PAGE REPLACEMENT GUIDE FOR
AMENDMENT 70
CLINCH RIVER BREEDER REACTOR PLANT
PRELIMINARY SAFETY ANALYSIS REPORT

(DOCKET NO. 50-537)

Transmitted herein is Amendment 70 to Clinch River Breeder Reactor Plant Preliminary Safety Analysis Report, Docket 50-537. Amendment 70 consists of new and replacement pages for the PSAR text and Responses to NRC Questions.

FIGURE Q220.39-1 TYPICAL MPHI MODEL AND STRAIN DIAGRAM

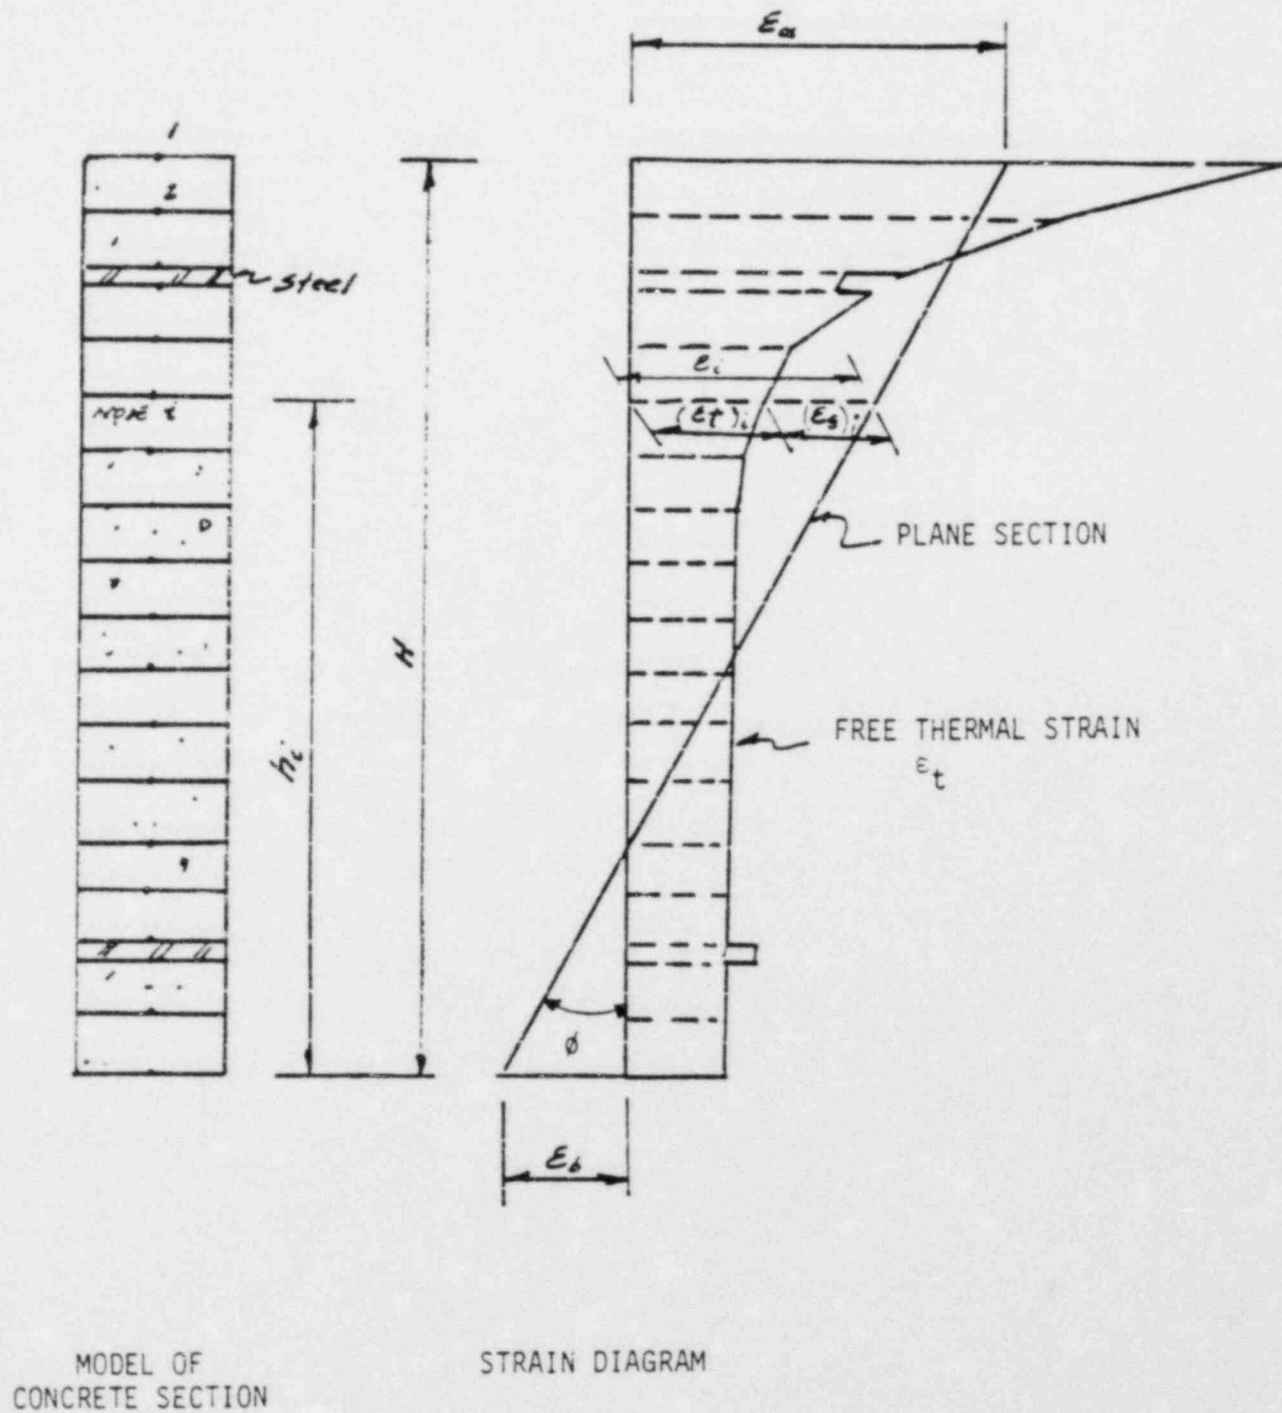
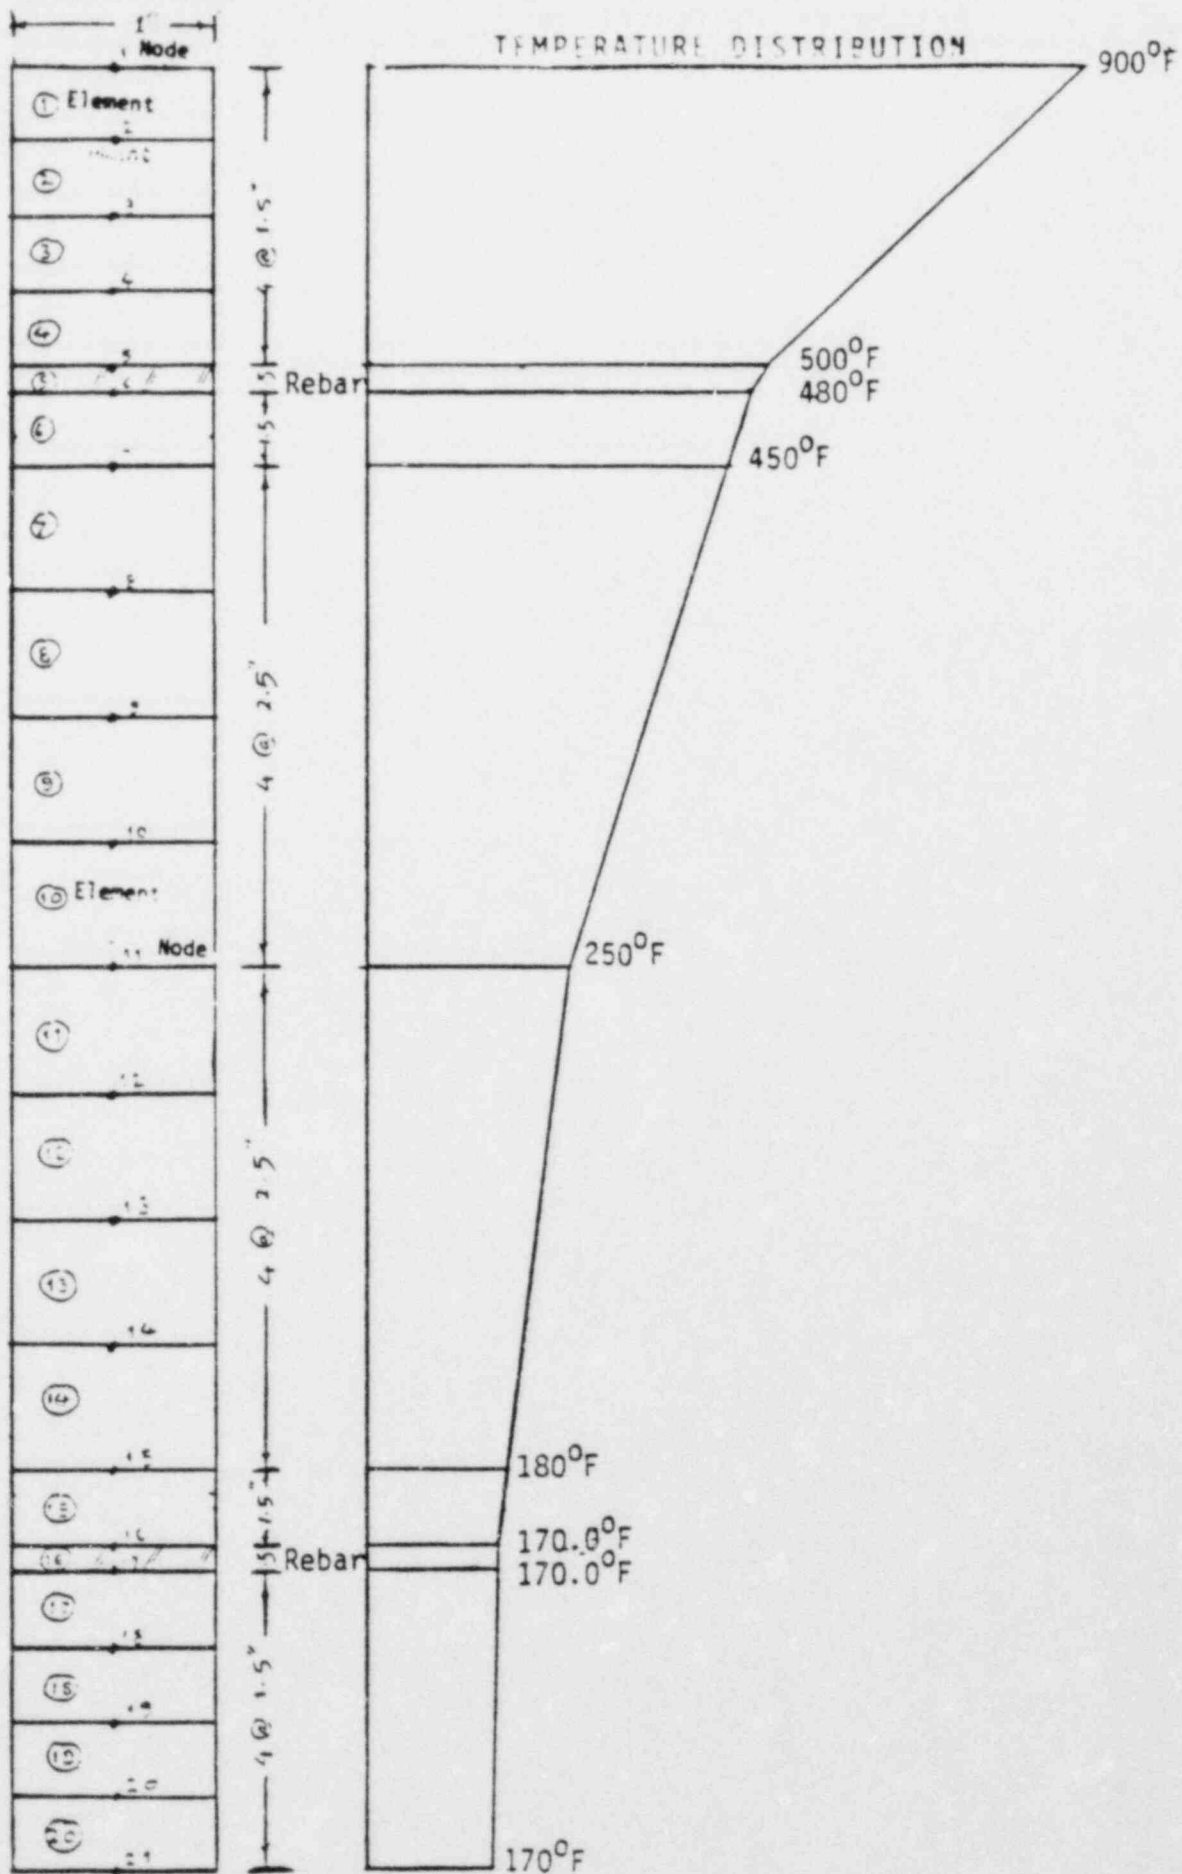
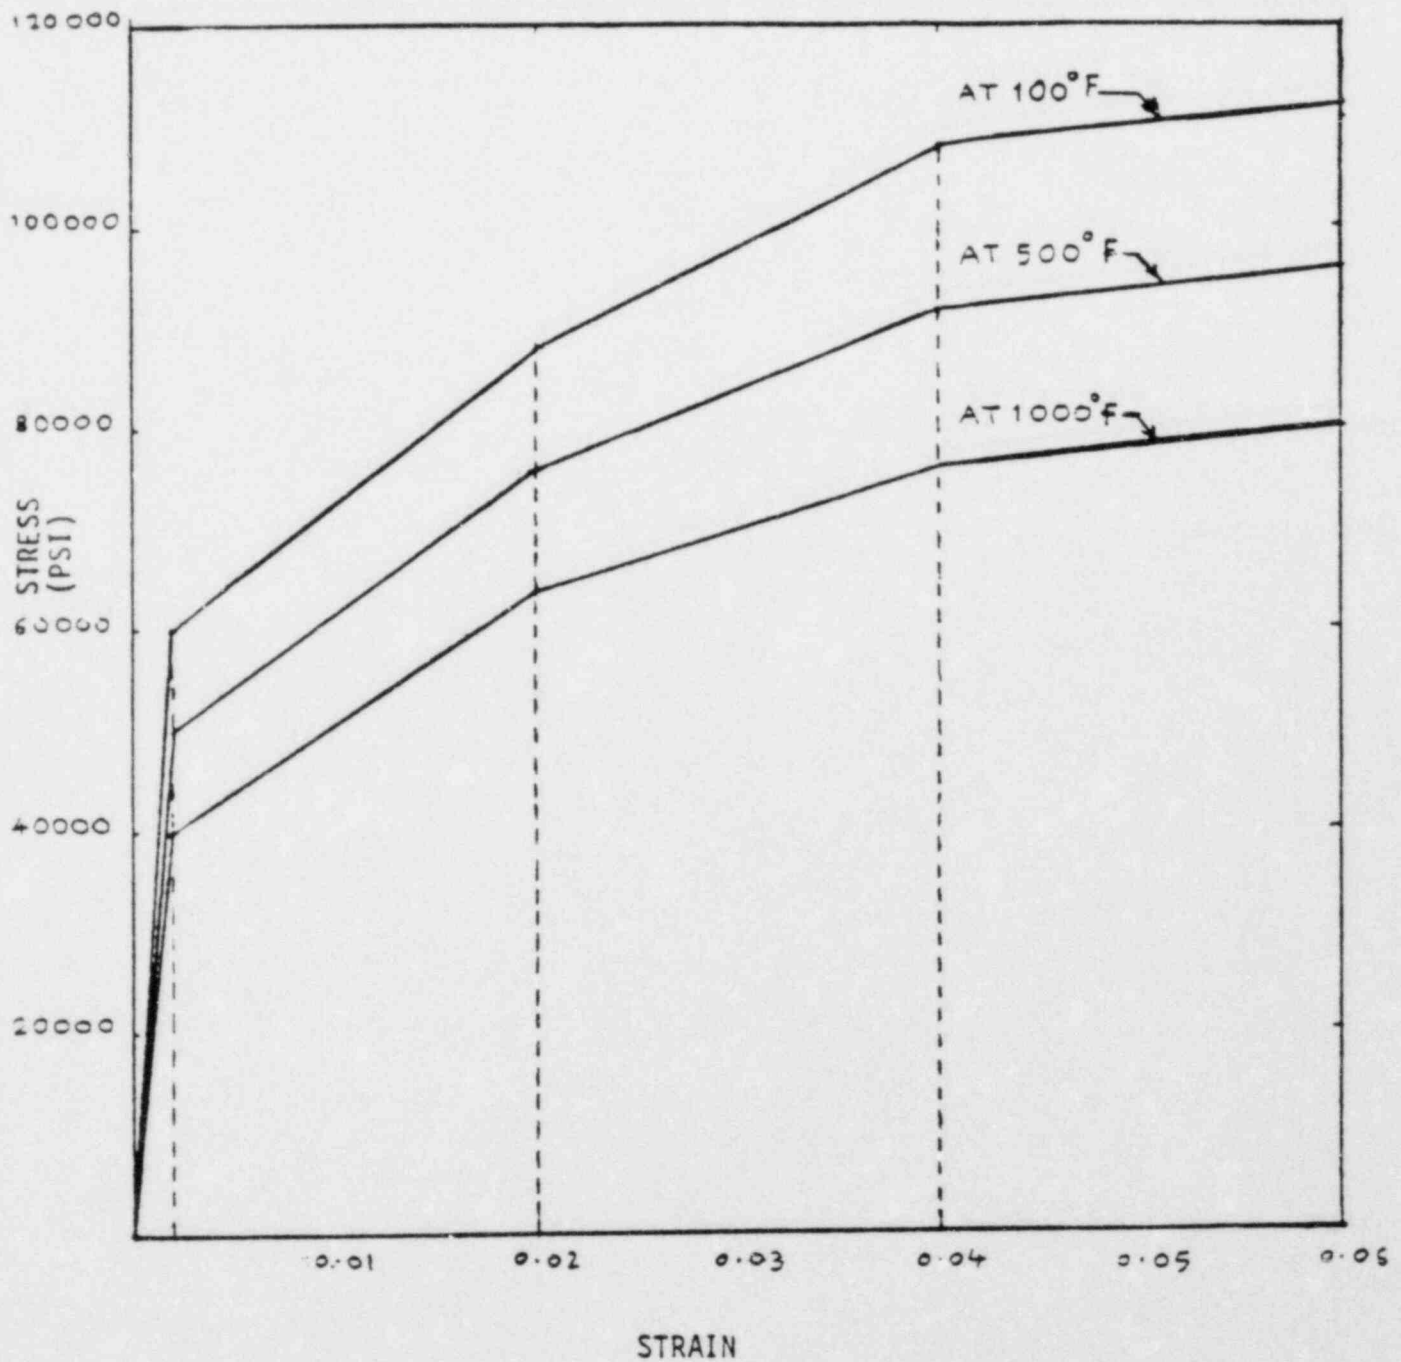
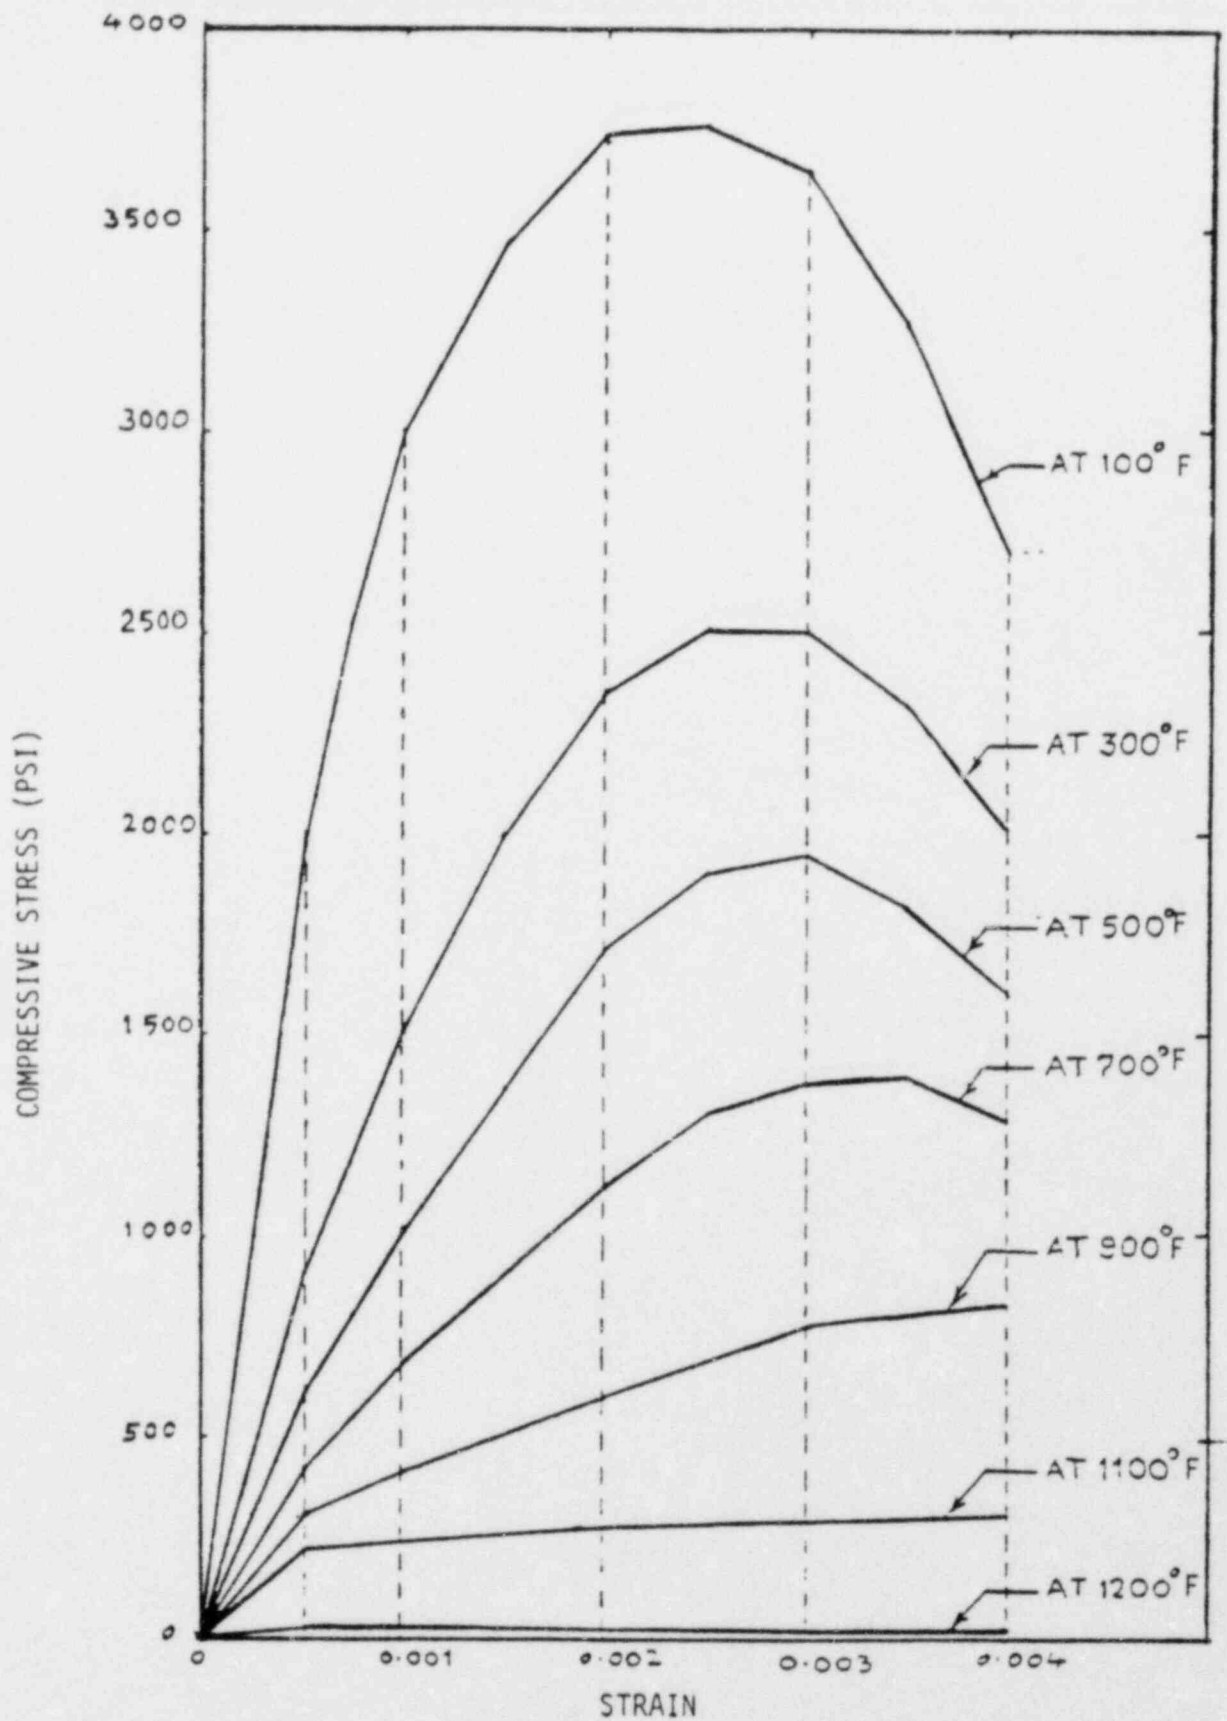
The applicant has provided information showing that such section failure do not occur before TMBDB requirements are met. Additional details should be provided to show how close these internal structures come to failure as the TMBDB scenario progresses. Rates at which failure is approached and times that failure is expected should also be provided. This should be done for all critical sections. This is particularly important because no factor of safety is applied to the section failure capacities.

Critical sections in the RCB structures have been or are being evaluated for rates of failure progression and expected failure times.

In accordance with the TMBDB scenario described in CRBRP 3, Vol. 2 the Reactor Cavity and the three Pipeway Cells are the only cells in the Reactor Containment Building that would be exposed to sodium. The base case scenario considers failure of the liner to occur at certain times and these failure times establish the minimum structural integrity requirements for the liner system. Since the liner system is anchored to concrete structures, failure of these structures (sectional capacity exceeded) is considered, conservatively, to imply potential liner failure so that the minimum times for structural integrity requirements for the liner apply also to the supporting concrete.
